## Attachment 1 – Response to Submissions

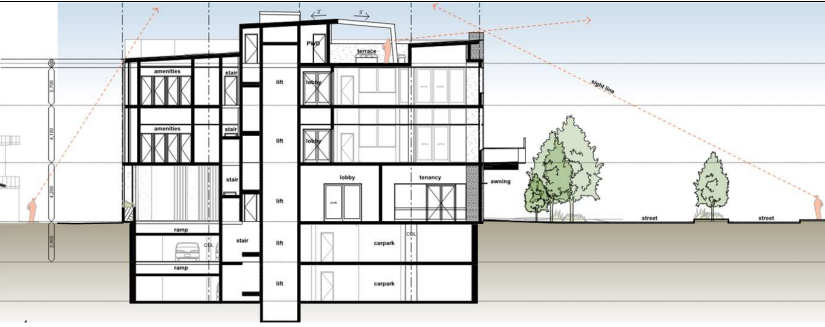
Traffic report notes Sunray Lane is 7m in width but measures 6m	 DP1264557 (being the underlying Deposited Plan for portion of the Town Centre east of Casuarina Way) shows Sunray Lane as being 7m wide – see snippet from DP below. The Traffic Impact Assessment is therefore correct. See snippet from DP below:

<p><u>Sunray Lane has an overall width of 7m by DP 1264557, and a road width of 5.7m as per the As-Constructed Survey submitted as part of this second RFI response. It is noted the kerbs to Sunray Lane are flush with the adjoining ground and measure 150mm in width each, providing an additional 300mm and thereby increasing the trafficable width of Sunray Lane to 6m.</u></p>
	 Access for garbage trucks	 Ensuring garbage truck access along public roads is a Council consideration. Council may wish to consider prohibiting parking along Sunray Lane to ensure clear access for garbage trucks and other rigid vehicles. It is noted this concern would be raised irrespective of the development proposed, given the site has been designated for rear loading.
	 Traffic generation and impacts from future development of medium-density sites not considered	 The Traffic Impact Assessment (TIA) submitted as part of the Modification application evaluated the number of vehicle movements likely to be generated by the proposal against existing vehicle movements and the capacity of the road network within the Casuarina Town Centre. In evaluating the capacity of the road network, the TIA has considered future development to an extent however, it cannot be entirely considered as it is currently unknown what will be developed on those allotments. As such, evaluating the proposal against existing vehicle usage and estimated capacity is considered appropriate.

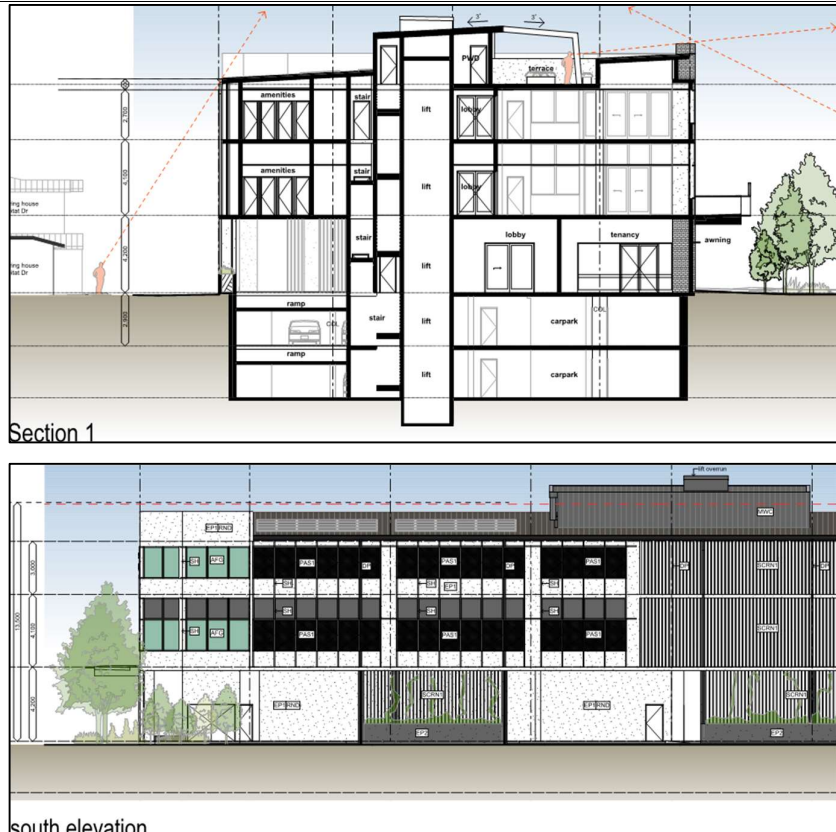
<b>Building Height Submissions: 15</b>	 Non-compliance with 13.6m building height prescribed under TLEP 2014	 The proposed built form is largely compliant with the 13.6m maximum height of building prescribed under the TLEP 2014 with GFL-L2 fully contained within the 13.6m. The exception is a portion of the parapet along the northern elevation, the

<p> Rooftop terrace exceeds height limits</p>	<p>roof over the proposed rooftop terrace, and the lift overrun. See height plane diagram below.</p>  <p>The northern parapet over the main building entrance measures approximately 400mm above the maximum prescribed height. This increase is indiscernible and does not result in any additional adverse impacts on the natural or built environment.</p> <p>The roof to the proposed rooftop terrace measures approximately 14.8m from natural ground level to the ridge of the terrace roof. As discussed in Section 3.2 of the Modification Report, the terrace is located relatively centrally to the roof of the third storey, with substantial setbacks to all four property boundaries. As a result, and as depicted in Section 1 of the Modification plans (see snippet below), the terrace will be largely indiscernible from private and public domains below. Furthermore, the substantial setbacks to all boundaries results in shadow impacts from the terrace falling across the third storey roof form only, ensuring no additional impacts are imposed on adjacent residential allotments or the public domain. The substantial setbacks also mitigate opportunities for overlooking from the terrace to areas of private open space of residential allotments adjacent to the site.</p>

<p>The maximum exceedance of the prescribed building height results from the lift overrun which measures approximately 15.3m from natural ground level. As with the rooftop terrace, the lift is located relatively centrally to the third storey roof form and will not cast additional shadows over adjacent areas of public and private open space, nor will it be visible from the public domain below.</p> <p>The exceedance to the maximum prescribed height of building will not result in any adverse environmental impacts.</p>
	<p> Floor to ceiling heights greater than necessary</p>	<p> Proposed floor to ceiling heights are required to allow for servicing, equipment and the required headspace and clearances above and around the equipment.</p> <p>Please refer to Attachment 2 – Response to Request for Information.</p>
	<p> Increased height will set a precedence</p>	<p> The partial fourth storey, being the rooftop terrace, is set substantially back from each boundary and will be largely undetectable from the public domain. No's 5 and 6 Grand Parade have both had four storey developments approved over them with the construction of Pama (5 Grand Parade) nearing completion. This, coupled with the fact the roof terrace takes up just 14.1% of the entire third storey roof form and is set lower than the proposed lift overrun, demonstrates that the partial fourth storey will not set a precedence and will provide a seamless transition between the four-storey developments that gatekeep Grand Parade at its western end, and the three storey sites at the eastern end, adjacent to the foreshore.</p>
